NEW YORK STATE DEPARTMENT OF ENVIRONMENTAL CONSERVATION

Subject: 3750 Monroe Avenue, Site #C828187

Sub-Slab Depressurization System - Relocation Work;

The New York State Departments of Environmental Conservation (NYSDEC) and Health (NYSDOH; collectively referred to as the Departments), have completed their review of the document entitled "Sub-Slab Depressurization System - Relocation Work" (the Work Plan) dated December 15, 2020 and prepared by LaBella Associates, D.P.C. for the 3750 Monroe Avenue site located in the Town of Pittsford, Monroe County. In accordance with 6 NYCRR Part 375-1.6, the Departments have determined that the Work Plan, with modifications, substantially addresses the requirements of the Brownfield Cleanup Agreement. The modifications are outlined as follows:

FIGURE 4

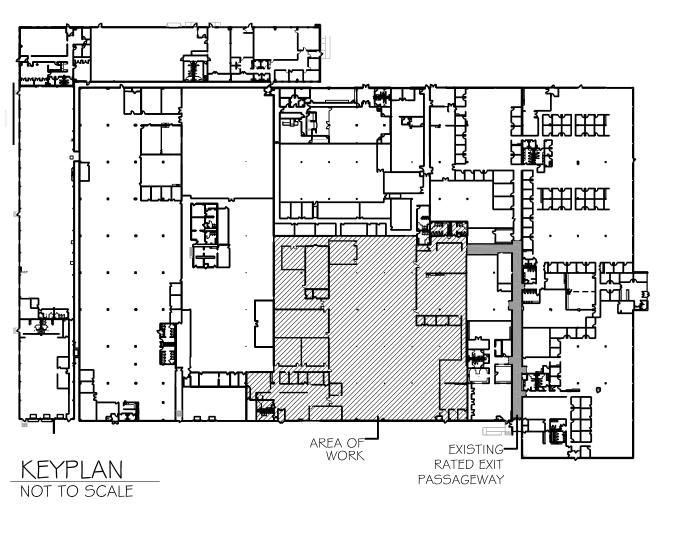
A total of five (5) SSDS points will be modified during this piping relocation work:

- P-27
- P-29
- P-30
- P-31
- P-32

The locations of these points are shown in the attached figure. It is anticipated that the original subslab suction points will not be affected, as only piping from the suction points will be relocated. At each point, the following procedure will be followed:
